NOTICE TO BIDDERS

TENDER B/SM 25/22: THE CONSTRUCTION OF POLKADRAAI WATER SUPPLY SCHEME

NB3.1 QUESTIONS

NB3.2 ADDENDUM

SW12

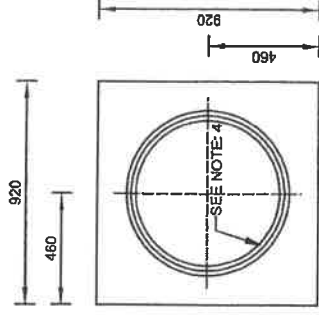
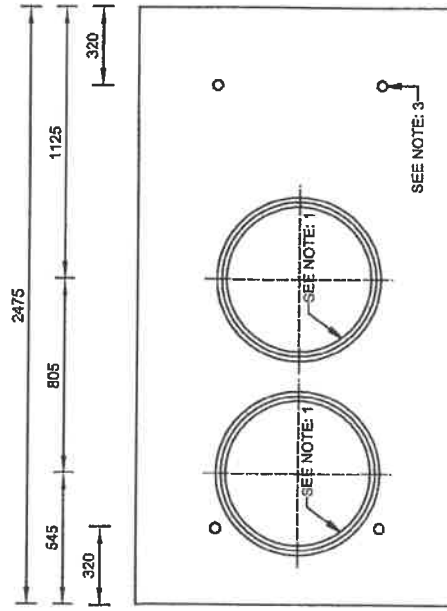
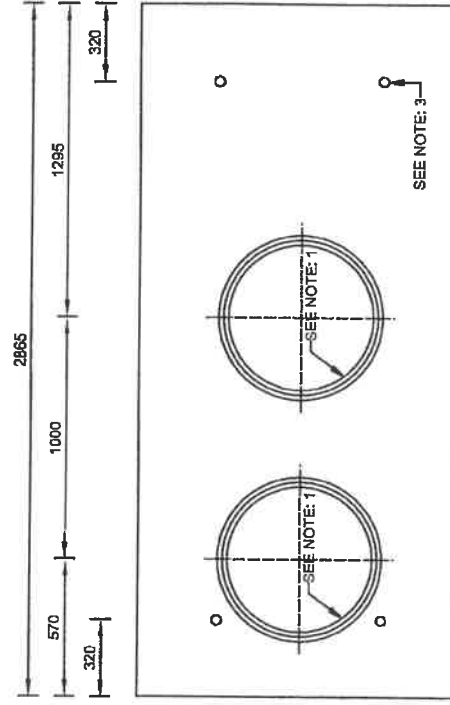
- Q12. *The tenderer requested that standard drawings SW11 and SW12 be provided as it is currently cut off.*
- A12. The correct drawings to be attached in Annexure B.
